## ADDENDUM

**ADDENDUM NO.:** 03  
**PROJECT NAME:** CIP Central Hearing Facility Roof and MEP Upgrades  
**PROJECT NO.:** 04044  
**CONTRACT NO.:** C1606  
**DATE OF ISSUE:** December 29, 2023

### NOTICE OF CHANGES, MODIFICATIONS, OR CLARIFICATIONS TO CONTRACT DOCUMENTS

**1 SECOND FLOOR EAST REFLECTED CEILING DEMOLITION PLAN**  
SCALE: 1/8"=1'-0"

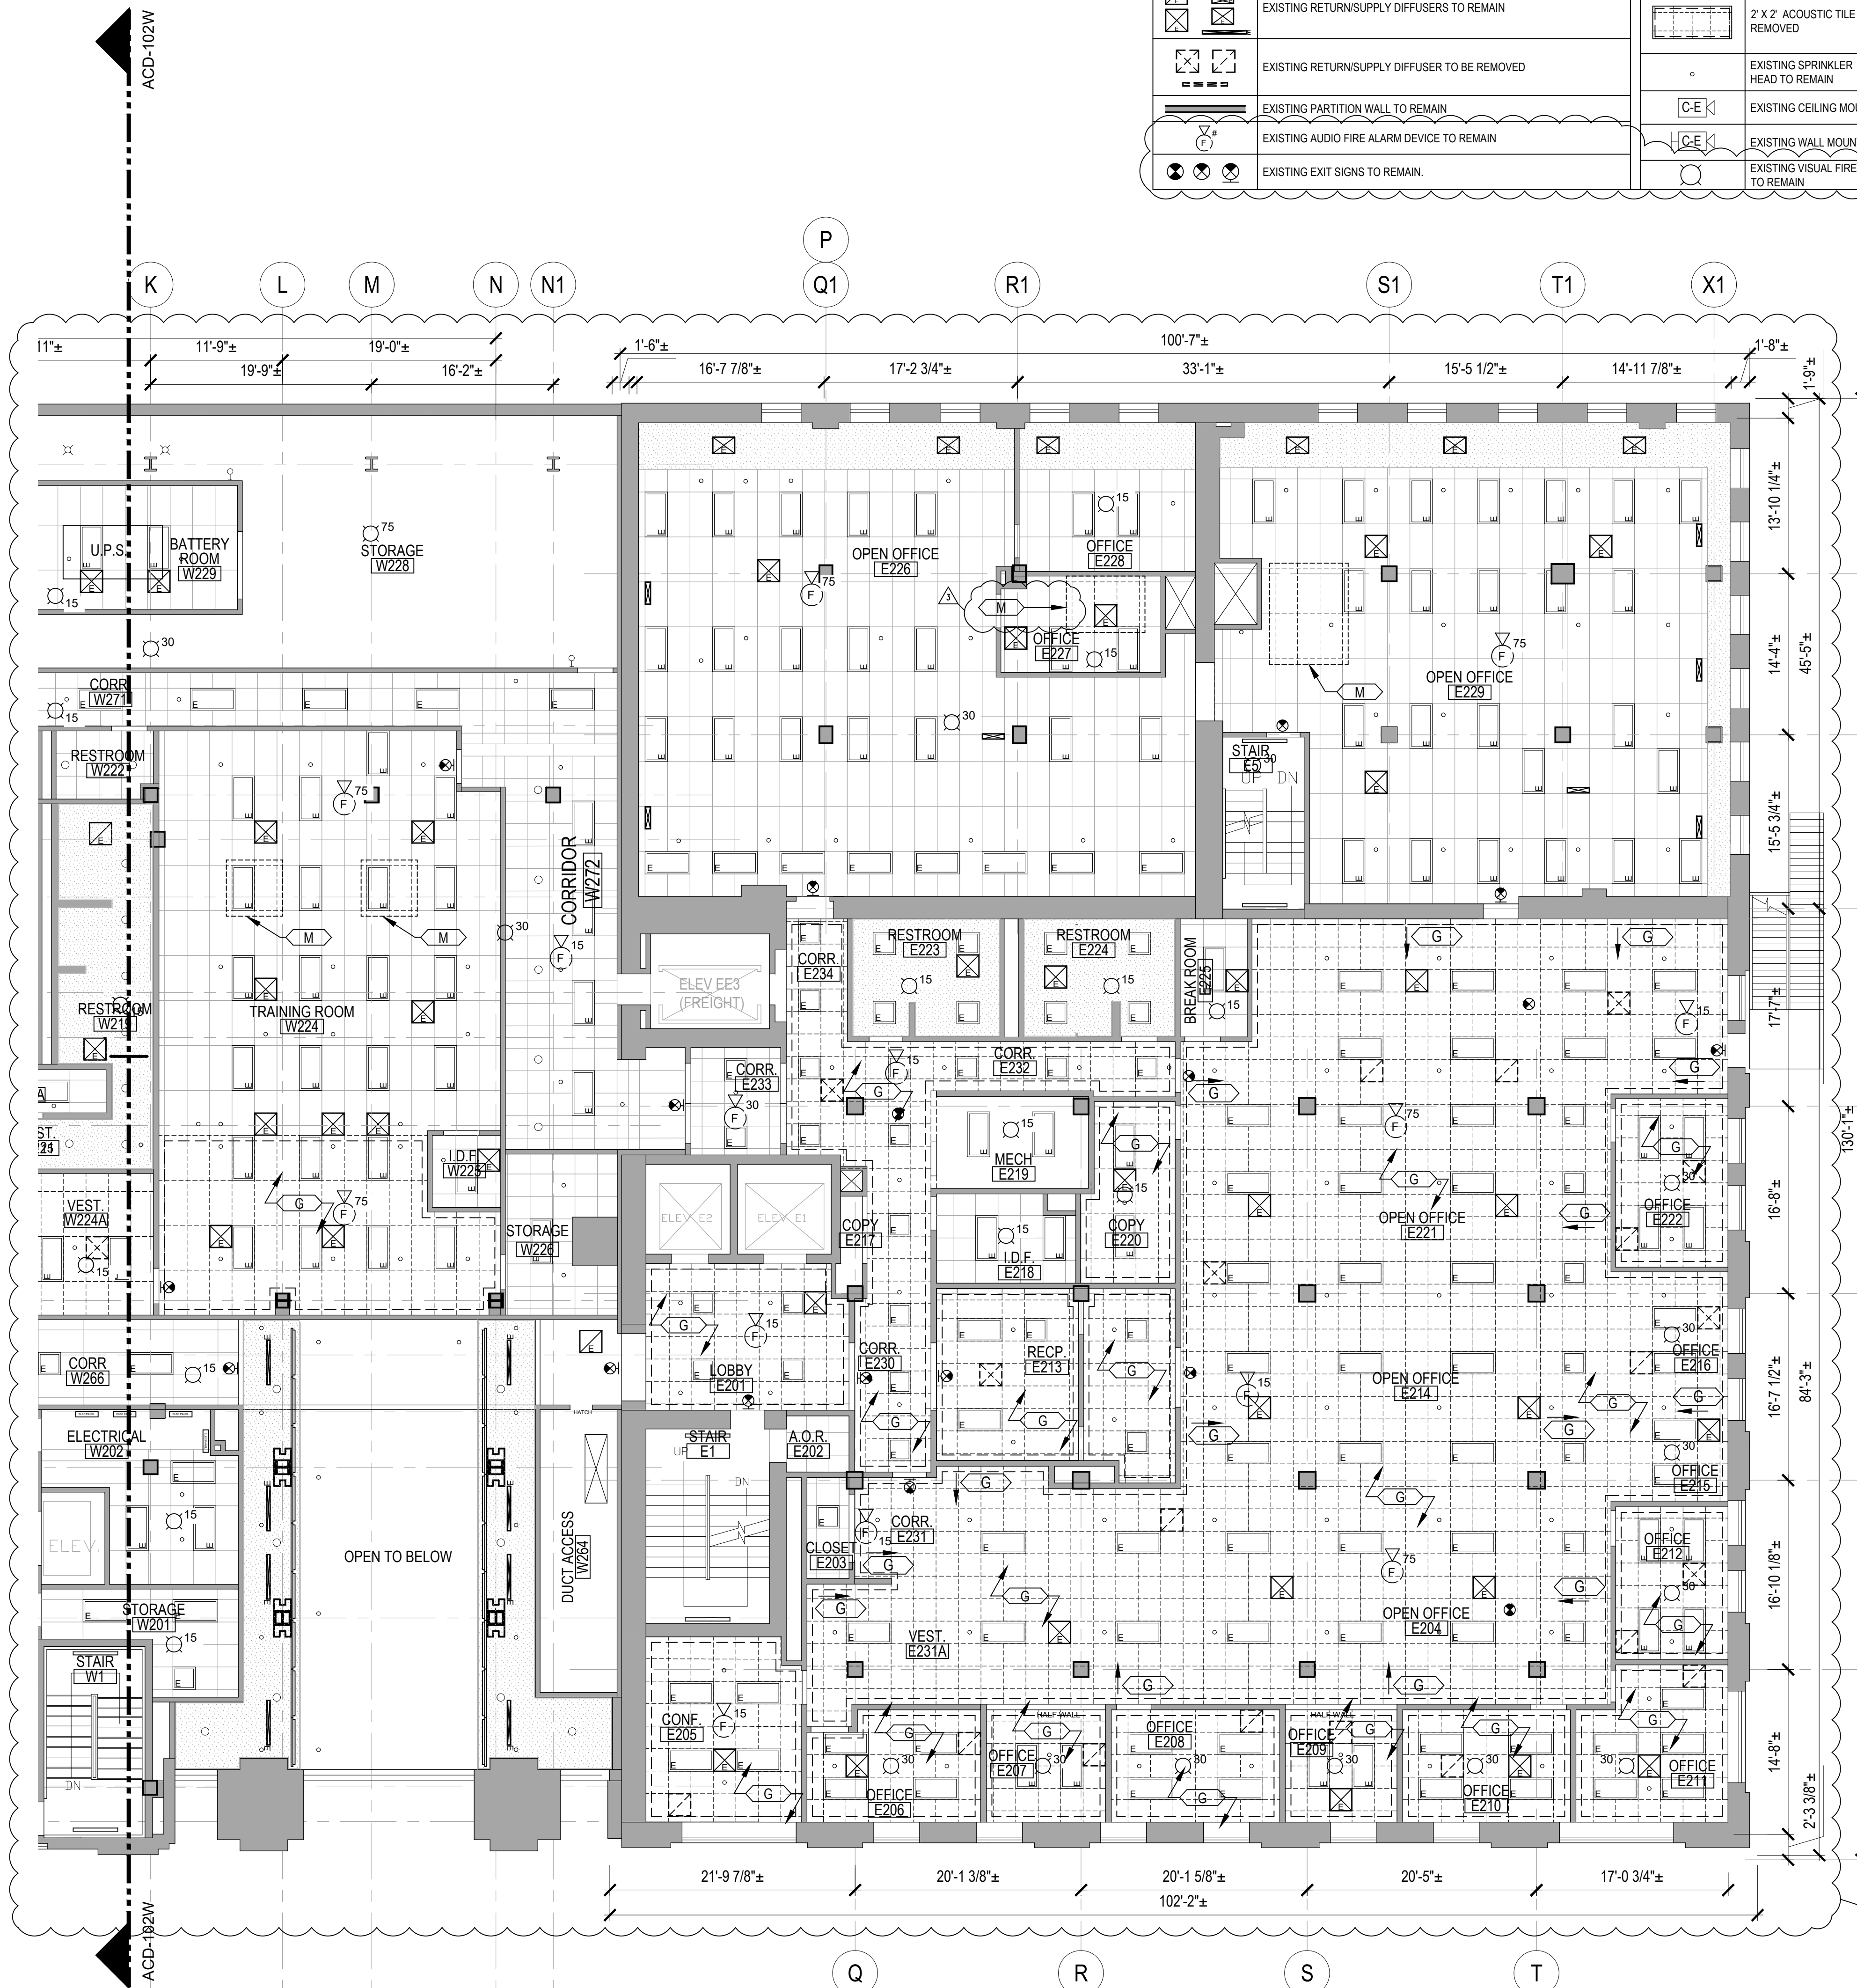
**Question:** On sheet ACD-102E there is a hatch line around Office Room E227 without a keynote. Please advise.

**Response:** Keynote M for room E227 on sheet ACD-102E has been added and is included in this Addendum.

### PLUMBING MATERIAL LIST

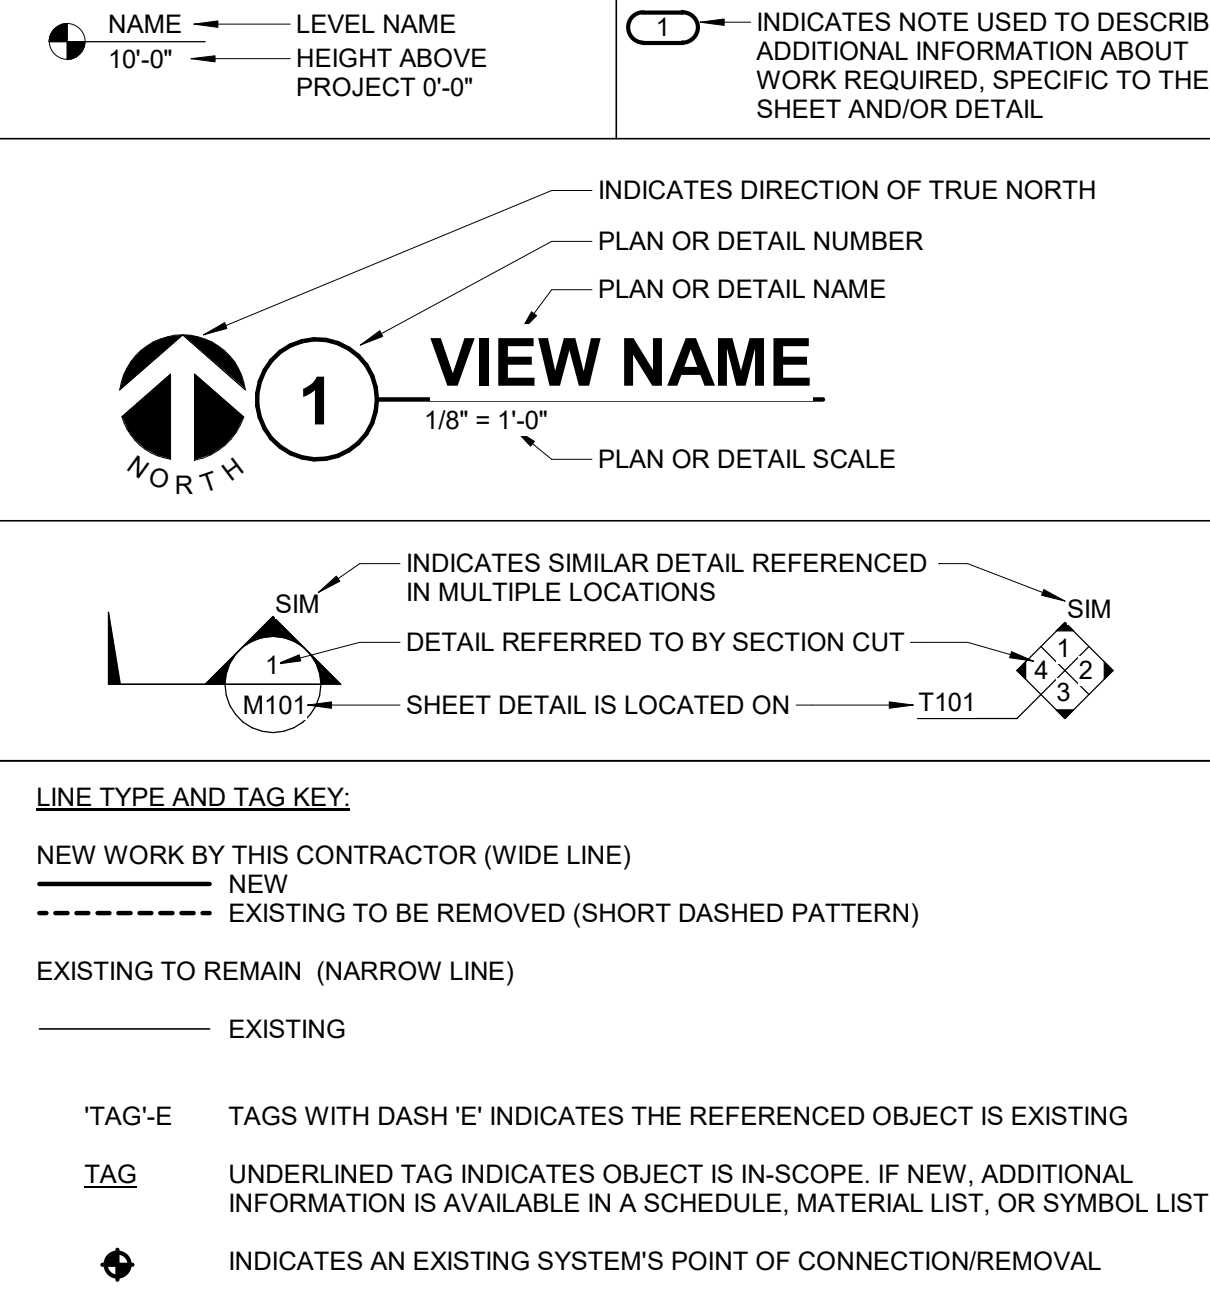
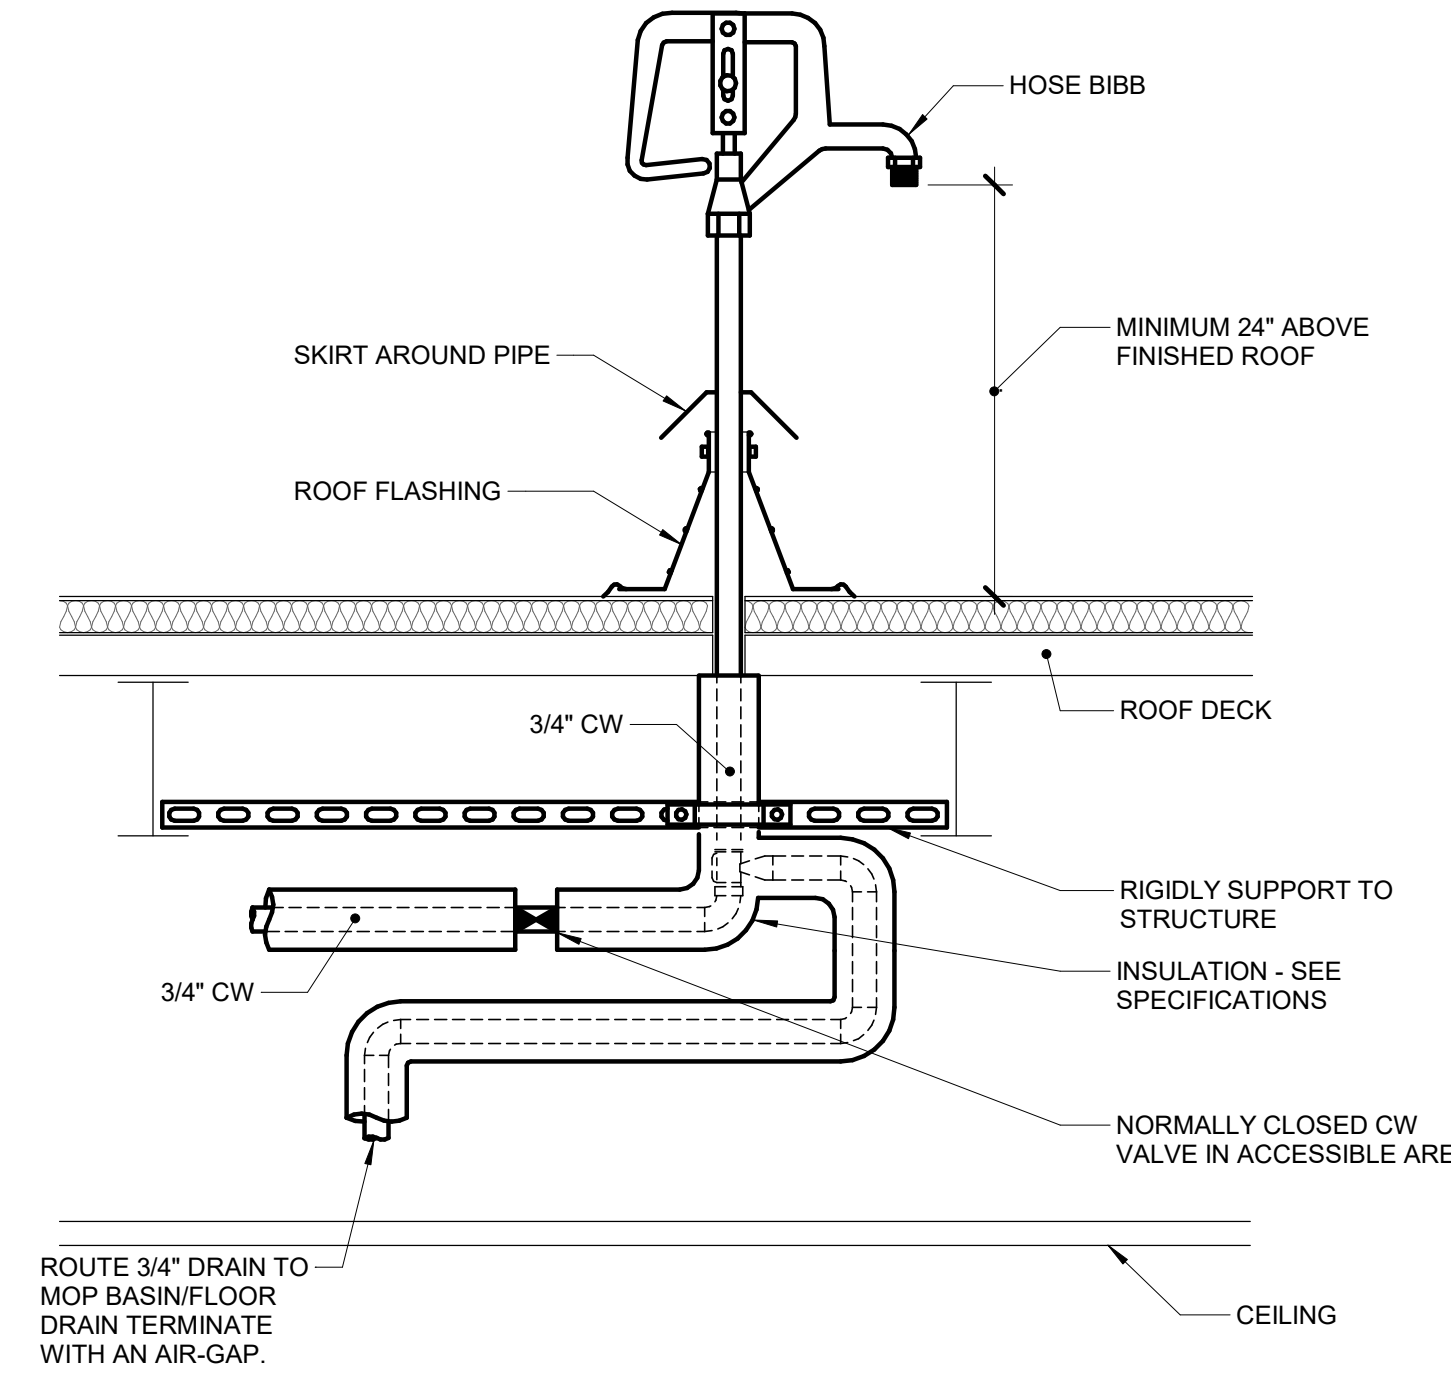
**Change 9** Drawing No. AR-102A – **REVISED** Key Notes 11, 39 and 47, dated 12.29.23  
**Change 10** Drawing No. P-000 – **REVISED** sheet to add Plumbing Piping Materials, dated 12.29.23

**Question:** There is plumbing shown on the drawings but no plumbing section in specifications. Please provide a specification section for plumbing.

**Response:** The project's plumbing scope is limited; therefore, the specification information is provided in the drawing notes. Please refer to the updated Plumbing Cover Sheet P-000 included in this Addendum.
